RAI Volume 2, Chapter 2.1.1.3, Second Set, Number 3:

Provide the technical basis for the scoring methodology and individual point scores used to develop the ignition source frequencies.

Figure 1. Sample Crystal Ball Report with Input Probability Distributions and Input Parameters

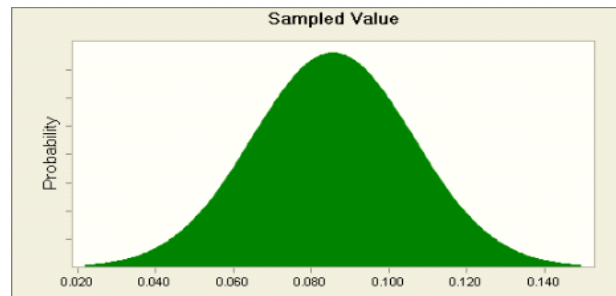
RAI Volume 2, Chapter 2.1.1.3, Second Set, Number 12: Provide the input and formulas that were used in Crystal Ball to generate the results displayed in spreadsheets, “CRCF Fire Frequency – No Suppression jwm.xls” and “CRCF CB Report.xls” included in Attachment H of BSC (2008b). Although the reference is to the Canister Receipt and Closure Facilities, the same need applies to analyses of fire-related initiating event frequencies for other facilities.

The normal distribution in Figure 1 is used with a mean of 0.086 and a 97.5-percentile value of 0.126, which is the input for cell H2. The shape of the distribution is illustrated in the plot. Crystal Ball uses standard formulas for the two probability distributions used in the model, normal and lognormal. The attached file “CB Input Examples.xls” is a copy of “CRCF Fire Frequency – No Suppression jwm.xls” with excerpted distribution inputs from “CRCF CB Reports.xls.” This example illustrates how the Crystal Ball inputs from “CRCF CB Reports.xls” are used within the “CRCF Fire Frequency – No Suppression.xls” spreadsheet. To determine the input distributions in “CRCF Fire Frequency – No Suppression jwm.xls,” match the cell number
